Work Order ID 128018

Item Name: Aft Crosstube, STD w/ Peg Steps (MKII)

D119-796-251 XTUBE ASSY (AW119 MKII AFT)

ECN 15-516

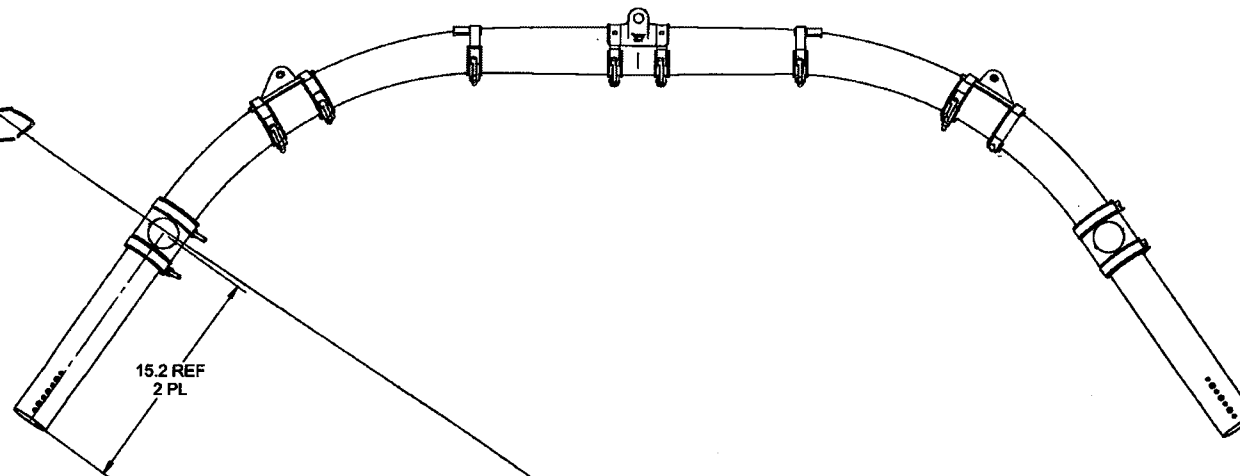
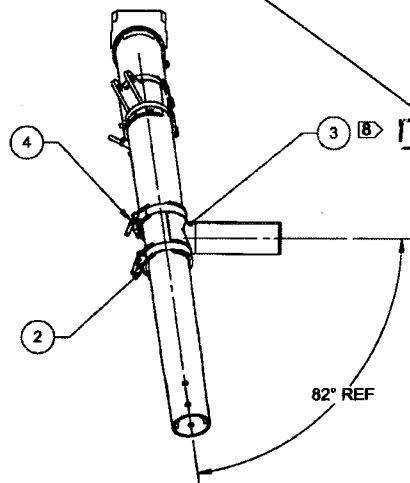
MS21920-25 CLAMP
A.P.
15.02.09

4 -> Scrap

C	ADD D5123-9 CUSHION, MS21920-28 CLAMPS, DELETE D5149-041, D5150-041, D2274	DB	14.11.24
B	D2274 RADIAL BLOCK WAS D5153-1, AN4C12A WAS AN4C10A	AP	14.10.04
A	NEW ISSUE	AP	14.09.03
REV.	DESCRIPTION	BY	DATE
DESIGN	AP	DART AEROSPACE LTD HAWKESBURY, ONTARIO, CANADA	
DRAWN	DB		
CHECKED	AP	DRAWING NO.	REV. C
MFG. APPR.		D119-796-251	SHEET 1 OF 1
APPROVED		TITLE	SCALE
DE APPR.	DS	XTUBE ASSY (AW119 MKII AFT) INT	
DATE	14.11.24	COPYRIGHT © 2014 BY DART AEROSPACE LTD THIS DOCUMENT IS PRIVATE AND CONFIDENTIAL AND IS RELEASED ON THE EXPRESS UNDERSTANDING THAT IT IS NOT TO BE USED FOR ANY PURPOSE OR COPIED OR REPRODUCED IN ANY FORM OR BY ANY MEANS WITHOUT WRITTEN PERMISSION FROM DART AEROSPACE LTD.

SECTION A-A

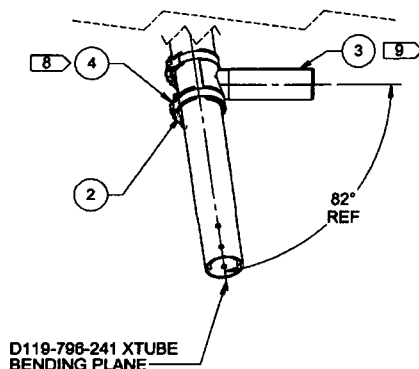
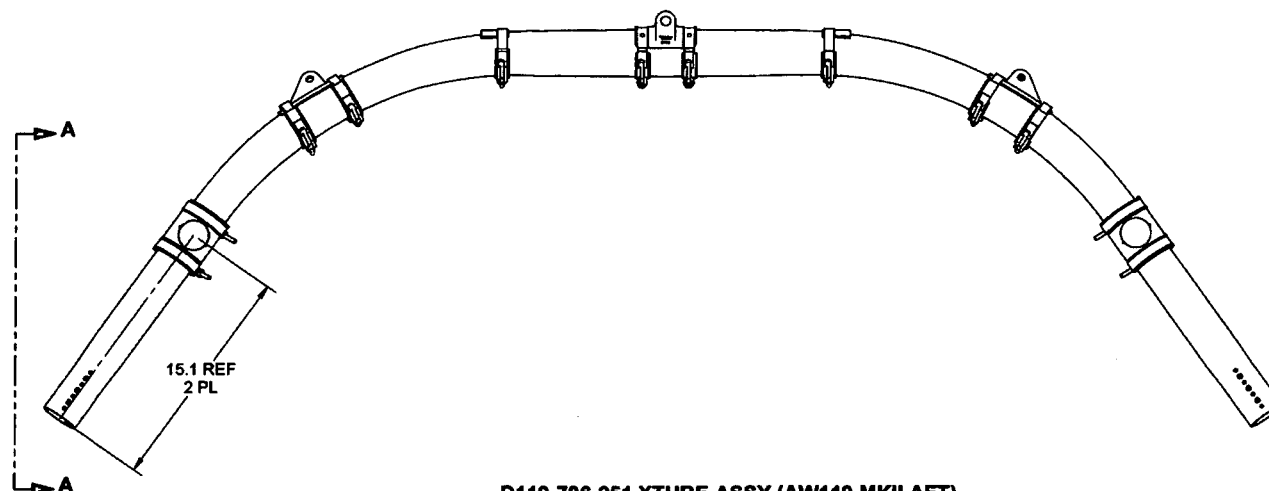
D	D5123-3 WAS D5123-9, MS21920-25 WAS -28, ADDED SECTION A-A	AP	15.01.19
C	RE-DESIGN STEP INSTALLATION	DB	14.11.24
B	D2274 RADIUS BLOCK WAS D5153-1, AN4C12A WAS AN4C10A	AP	14.10.04
A	NEW ISSUE	AP	14.09.03
REV.	DESCRIPTION	BY	DATE
DESIGN	AP	DART AEROSPACE LTD HAWKESBURY, ONTARIO, CANADA	
DRAWN	AP		
CHECKED	DB	DRAWING NO.	REV. D
MFG. APPR.	DD	D119-796-251	SHEET 1 OF 1
APPROVED	HS	TITLE	SCALE
DE APPR.	DS	XTUBE ASSY (AW119 MKII AFT)	NTS
DATE	15.01.19	COPYRIGHT © 2014 BY DART AEROSPACE LTD THIS DOCUMENT IS PRIVATE AND CONFIDENTIAL AND IS SUPPLIED ON THE EXPRESS CONDITION THAT IT IS NOT TO BE USED FOR ANY PURPOSE OR COPIED OR COMMUNICATED TO ANY OTHER PERSON WITHOUT WRITTEN PERMISSION FROM DART AEROSPACE LTD.

- 1) MATERIAL: N/A
- 2) FINISH: NONE
- 3) TOLERANCES: PER DART QSI 018 UNLESS OTHERWISE NOTED
- 4) UNITS: INCHES UNLESS OTHERWISE NOTED
- 5) BREAK SHARP EDGES: N/A
- 6) IDENTIFICATION: IDENTIFY PER DART QSI 044 METHOD 6.5
- 7) WEIGHT: 29.9 lbs
- 8) TORQUE MS21920-25 CLAMPS TO 50 IN-LBS MAX
- 9) LOCATE STEP USING POST FITTING ON CROSSTUBE
